Service Information Letter - Fuel Systems

No. 17, Rev. 1

SUBJECT: TOOLING CHANGE FOR ALL RSA FUEL INJECTORS.

PURPOSE: To introduce a new type Loctite Applicator, Part Number 2550982.

Loctite Applicator P/N 2550982

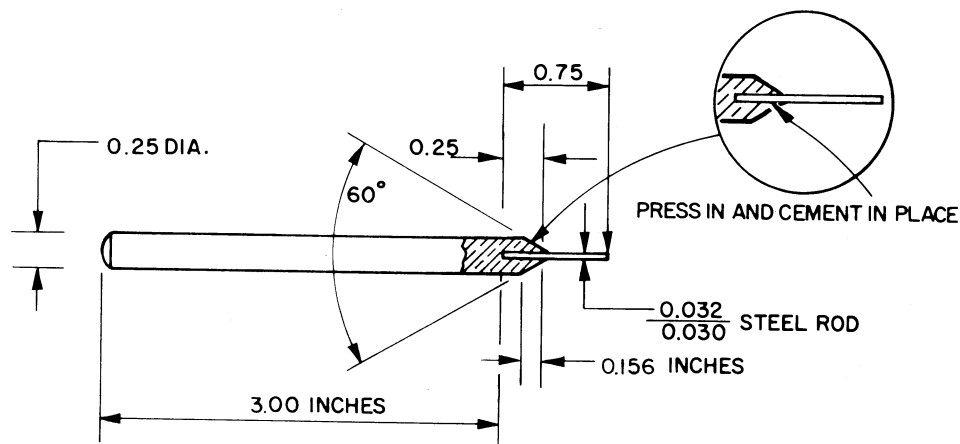
CAUTION: USE ONLY APPLICATOR PART NUMBER 2550982 AND APPLY LOCTITE VERY SPARINGLY. EXCESSIVE LOCTITE IS LIKELY TO TRAVEL DOWN THE STEM AND LOCK-UP THE REGULATOR AIR SIDE.

The new Loctite applicator is introduced to reduce the amount of Loctite applied to the regulator nut, part number 2539449.

To apply Loctite, dip the pointer of applicator, part number 2550982 into Loctite and carefully deposit a small amount of Loctite to the center of the regulator nut and assemble on stem.

After final calibration, apply a small amount of Loctite to the threads above the nut.

Loctite applicators, part numbers 2550998 and 2550999 are not to be used.
